Title - Sujet Fit-up, 4th Floor-Moncton (HC)	
Solicitation No. - N° de l'invitation EC096-183244/A	Amendment No. - N° modif. 001
Client Reference No. - N° de référence du client R.083347.002	Date 2018-05-03
GETS Reference No. - N° de référence de SEAG PW-\$PWJ-012-5393	
File No. - N° de dossier PWJ-8-41002 (012)	CCC No./N° CCC - FMS No./N° VME
Solicitation Closes - L'invitation prend fin at - à 02:00 PM on - le 2018-05-08	Time Zone Fuseau horaire Atlantic Daylight Saving Time ADT
F.O.B. - F.A.B. Plant-Usine: <input type="checkbox"/> Destination: <input checked="" type="checkbox"/> Other-Autre: <input type="checkbox"/>	
Address Enquiries to: - Adresser toutes questions à: Martin (PWJ), Lisa M.	Buyer Id - Id de l'acheteur pwj012
Telephone No. - N° de téléphone (506) 962-5328 ()	FAX No. - N° de FAX (506) 851-6759
Destination - of Goods, Services, and Construction: Destination - des biens, services et construction:

Addendum 1

CANADIAN HERITAGE
4th FLOOR FIT-UP
1045 MAIN STREET
MONCTON, NB

SK-1

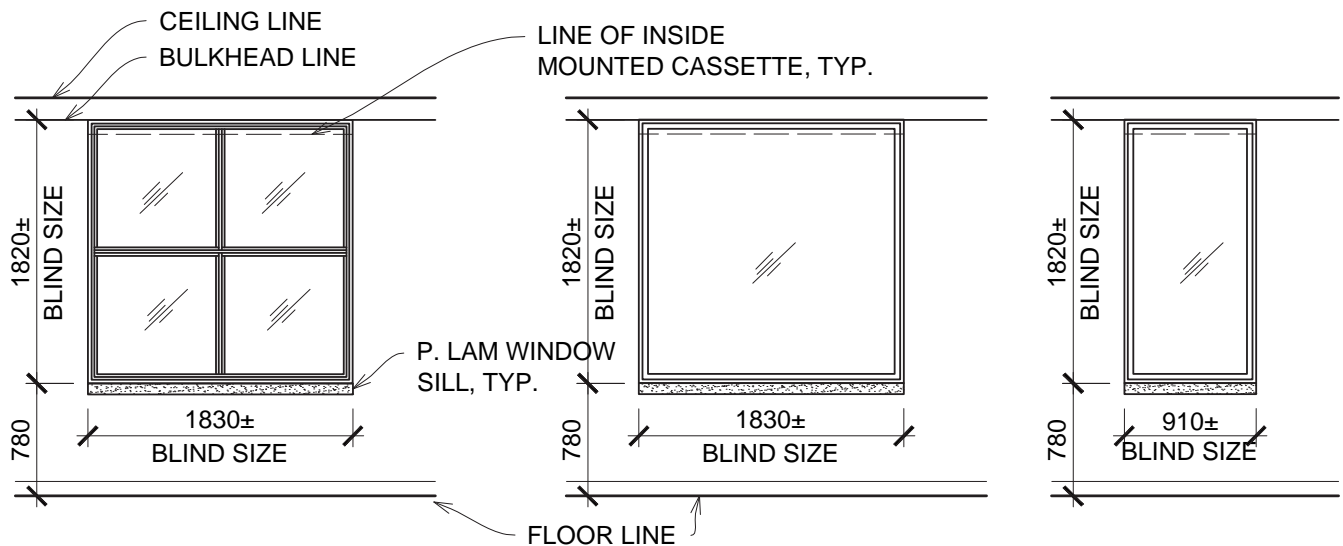
Also, can you confirm the height of all the windows that require window treatments?

1. Revise Key Note 1 on Construction Plan to read - Key Note 2 in Medium Meeting Room 4521 and Small Meeting Room 4532.
 2. Add SK-1 drawing attached for window treatment and sill sizes

See SK-1 attached to Addendum No 1
